September 11, 2020

File No. WLBZB 2020-05

Re: Engineering Review No.1  
Tina Maria Trace/Ruggerio (ZB 2020-05)  
Bulk Variance Application  
10 Homestead Avenue  
Block: 112 Lot: 5.01; Zone: R-10

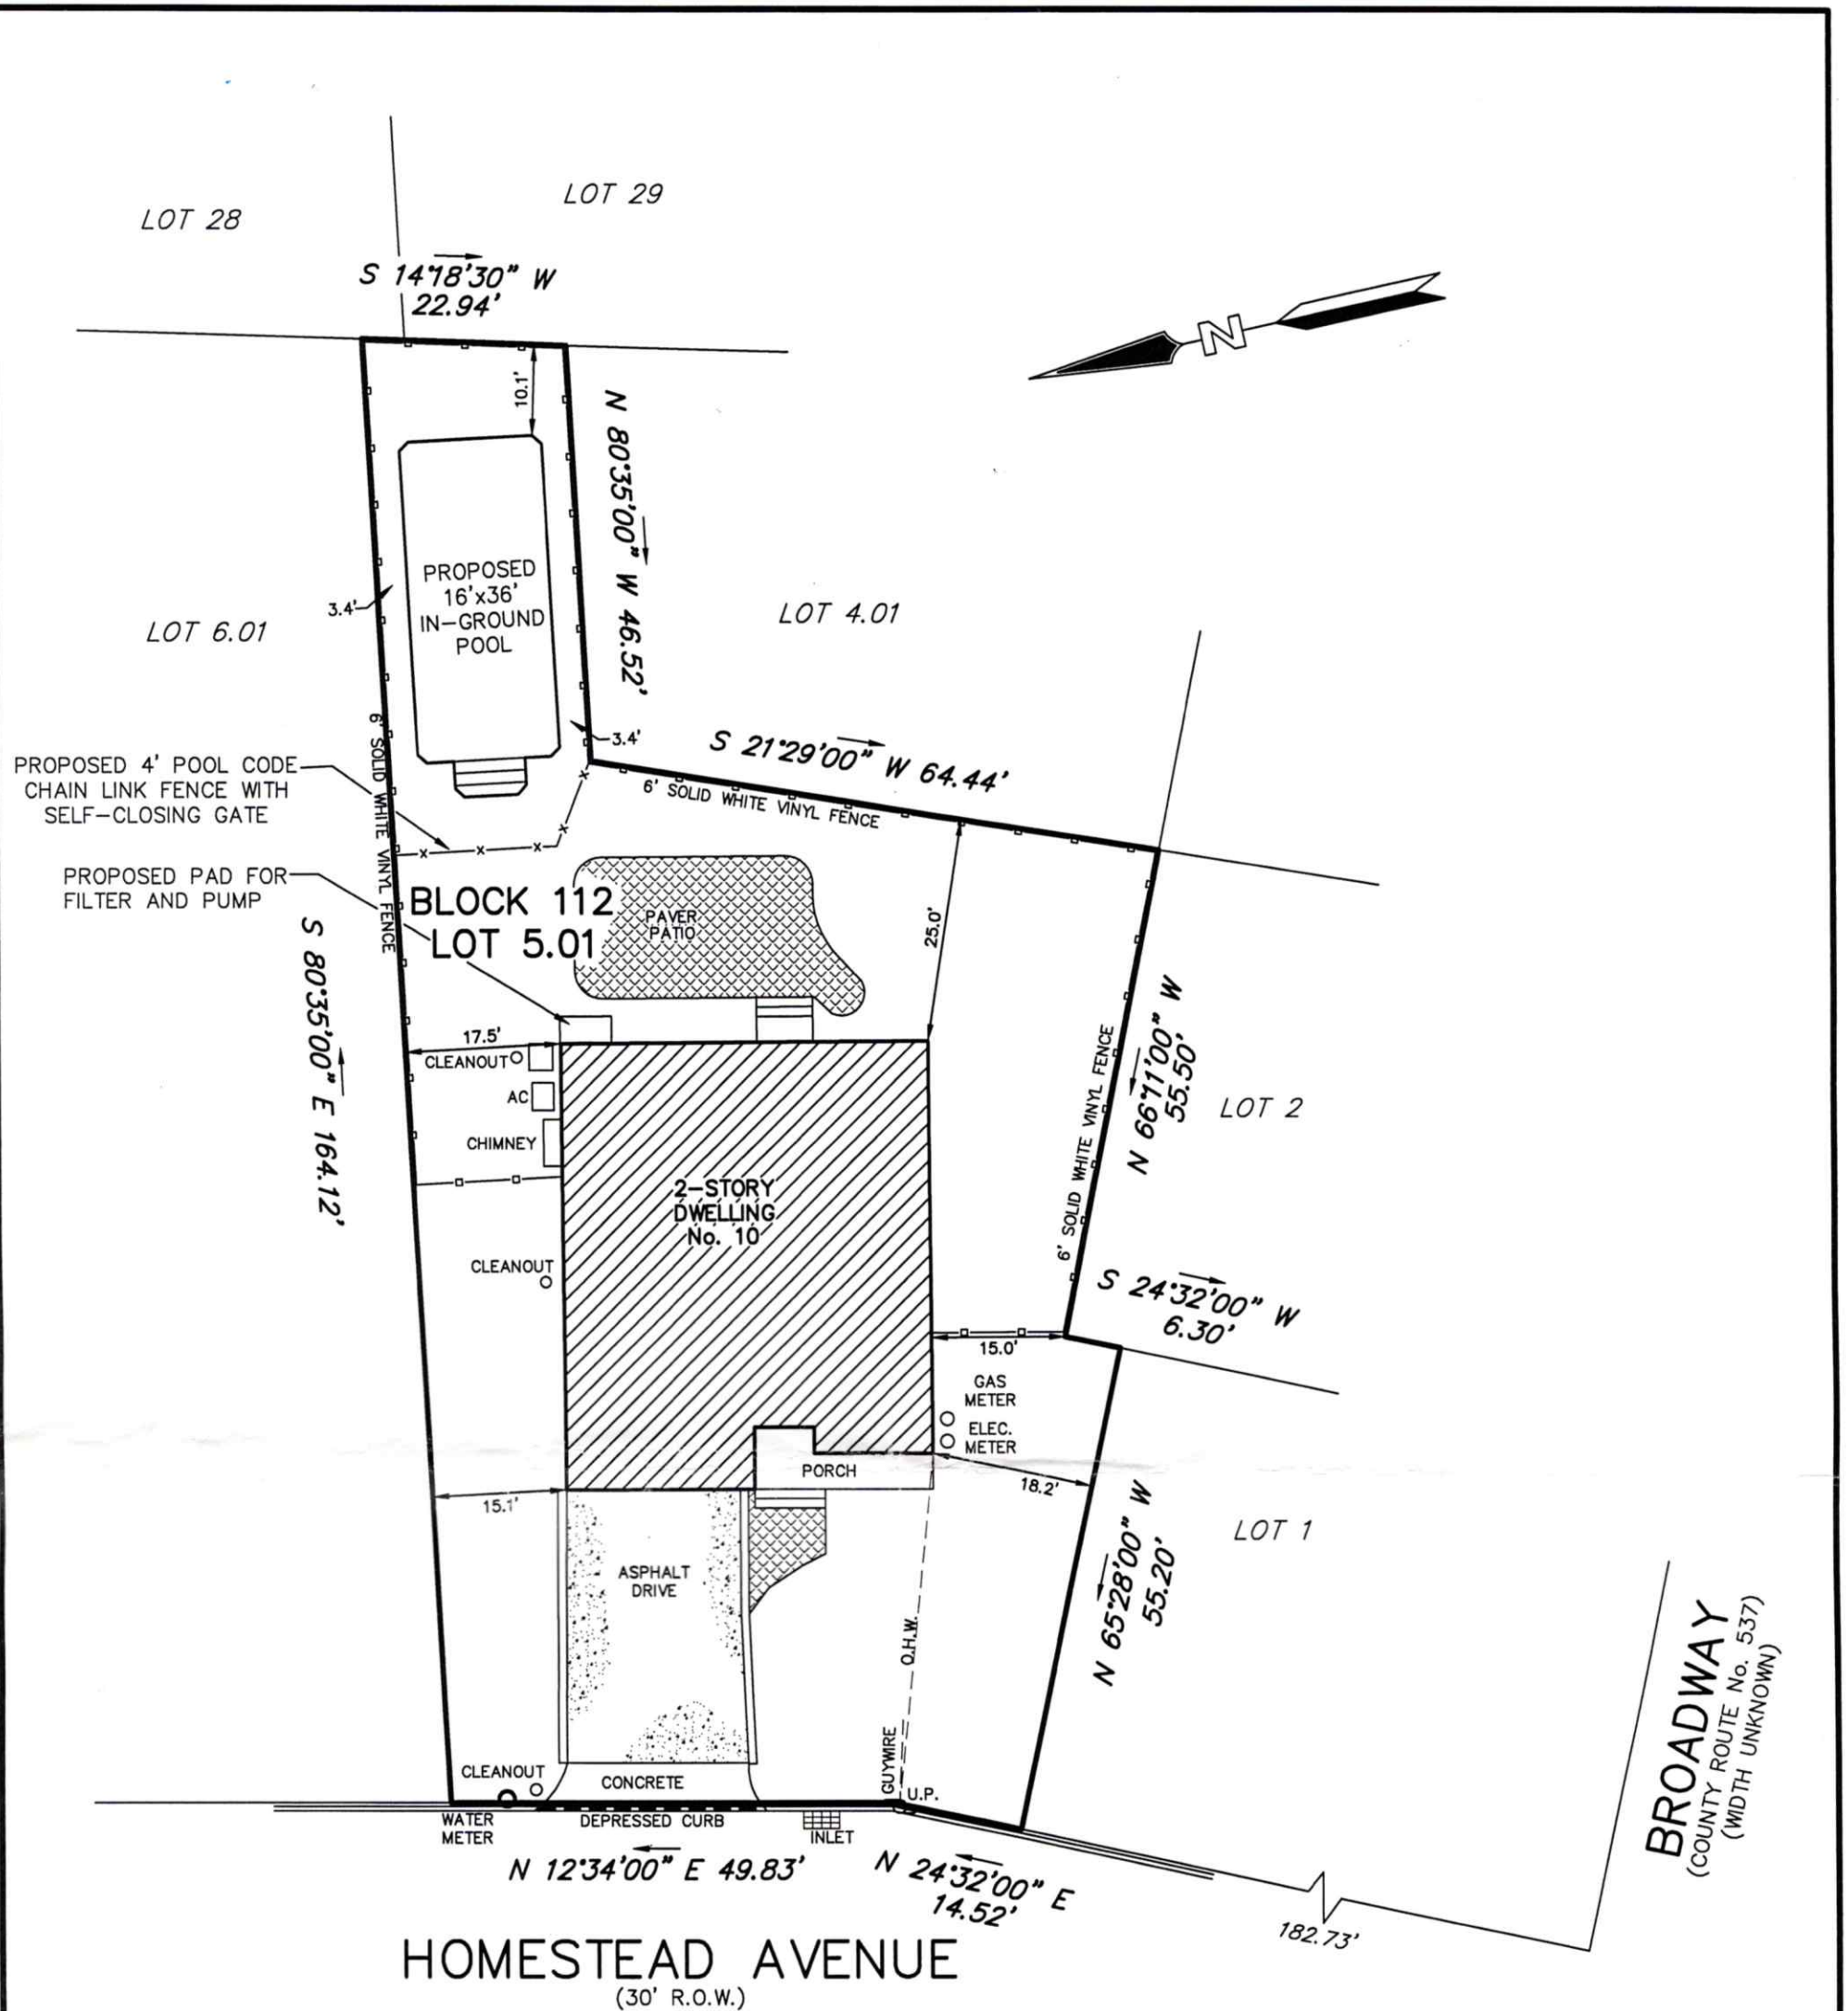
resolution grants approval for the location of the pool. A coverage variance was not noted. The resolution and a copy of the survey provided to the Borough after construction is attached. The 2006 plan does not show the shed or the additional pavers around the pool and in the rear of the home. These is added to the coverage calculation for the site by today's definition. I see the name on the current application is different than that of the 2006 applicant. The applicant should address when they purchased the property. I have attached NJDEP 2007 imagery which indicates pavers were installed as shown on the current plan. I am advised that the definition of coverage changed around 2008 to include patios etc. in the calculation and that under the old ordinances the patio would not have counted toward coverage. At the time of this letter I am in the process of confirming the ordinance change date. If correct the added pavers would not have required additional relief at that time of the pool approval. See comments 4.2 and 4.3 to follow.
